Title of report: Lingfield Road-Facilitate contra-flow cycling

Subject: Lingfield Road-Facilitate contra-flow cycling

LINGFIELD ROAD CONTRA-FLOW CYCLE LANE – VILLAGE

Statutory consultation - 18th February 2021

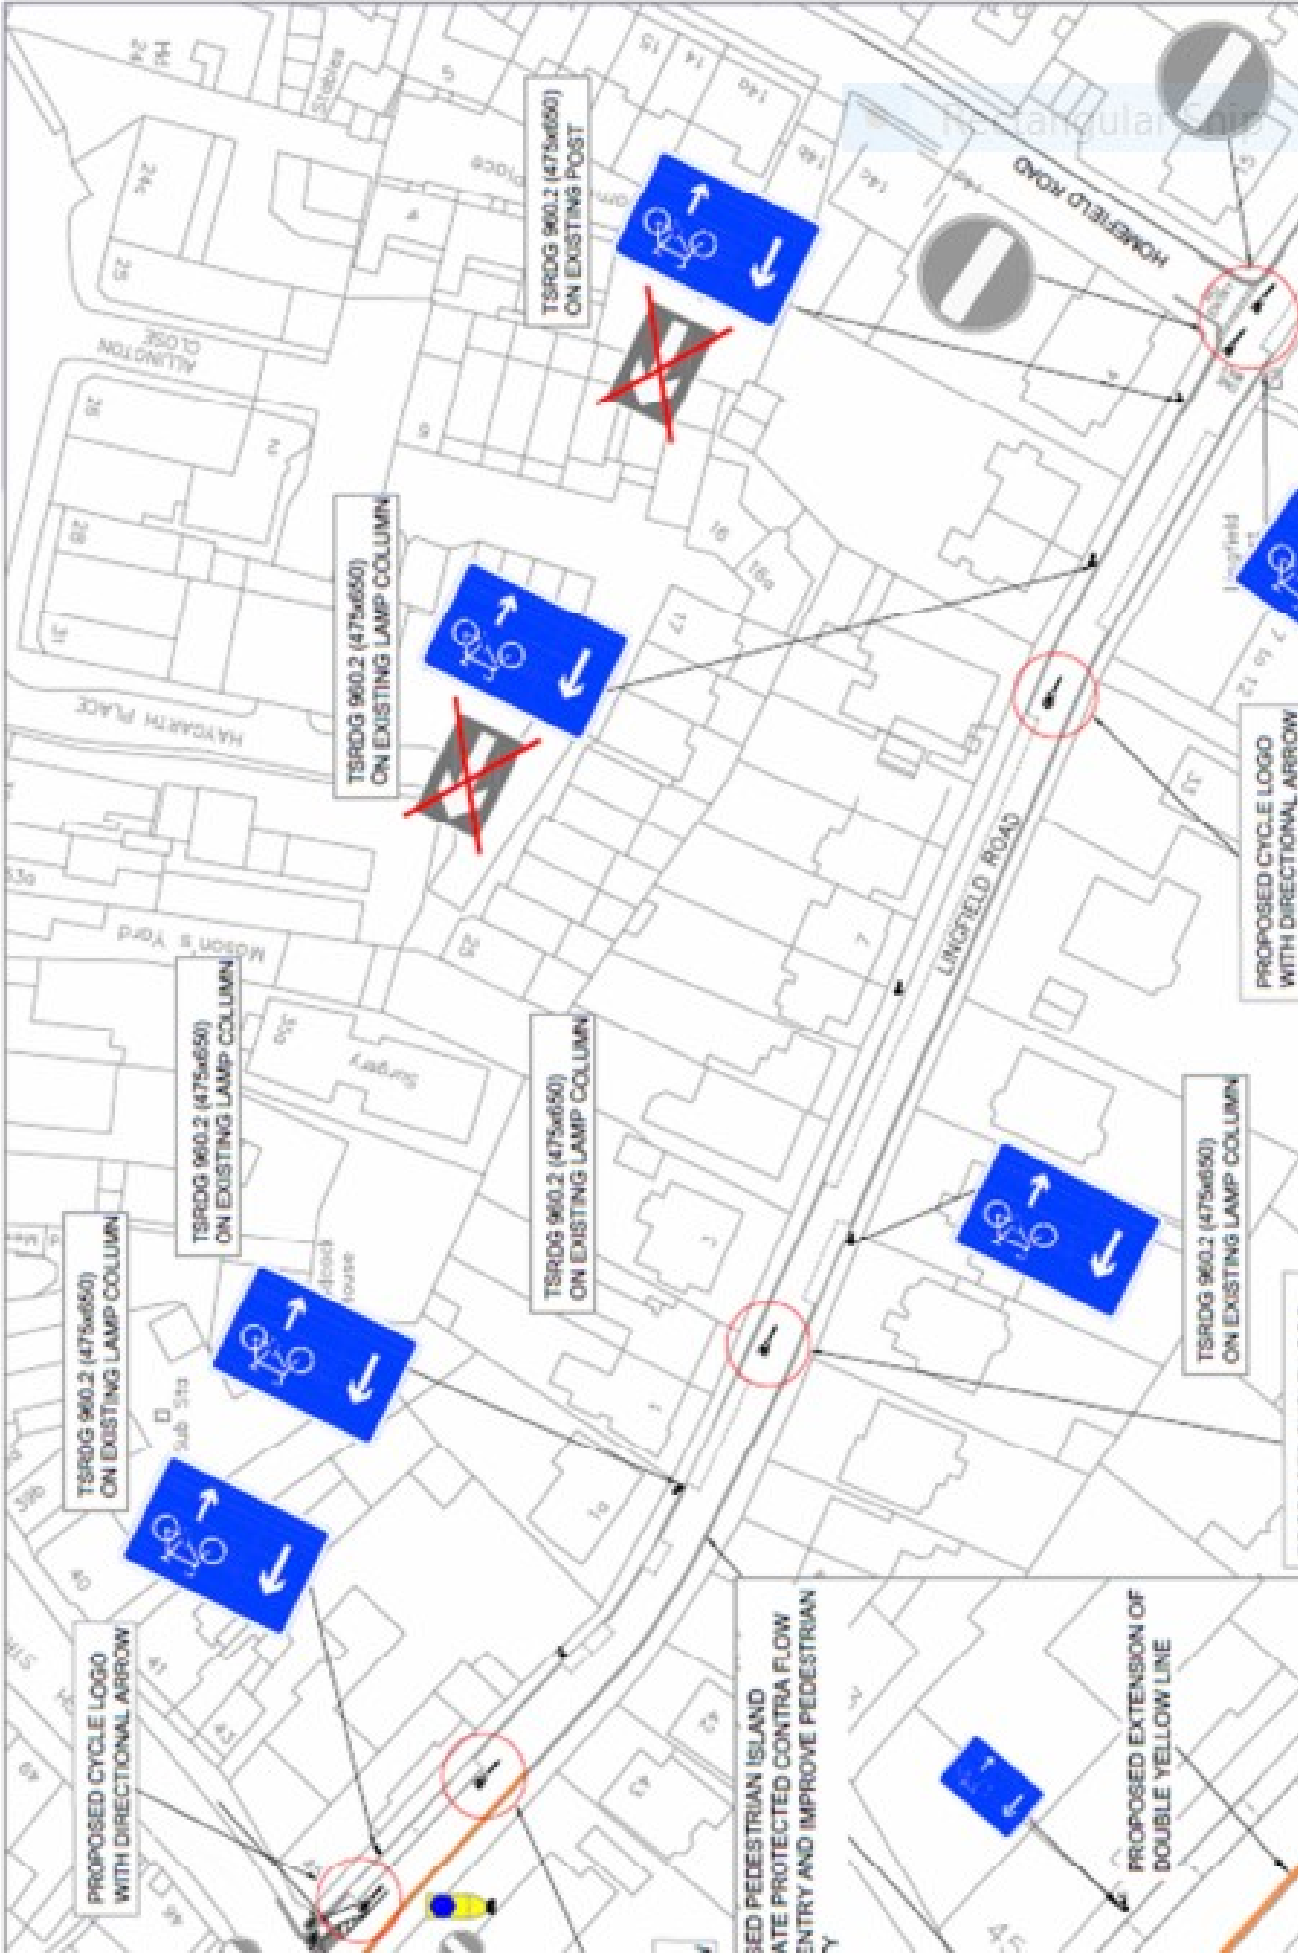
THE PLAN DETAILS ARE TOO SMALL TO READ ALTHOUGH THE MUTUAL BENEFIT TO EITHER PARTY SEEMS UNWORKABLE.

Further, car parking in Wimbledon is scarce and this proposal suggests removing 4 or possibly 5 car park spaces by placing additional double yellow lines on the last 20 m on the right at the end of Lingfield Road which is to be regretted.

It is not clear from the plan what is to happen to the parking spaces at the end of the road, but I suspect that with the suggested changes some spaces will be lost. We have already lost two spaces at the top end of the road within the last year or two (with no consultation). There is already considerable pressure on parking in this road. We cannot afford to lose further spaces.
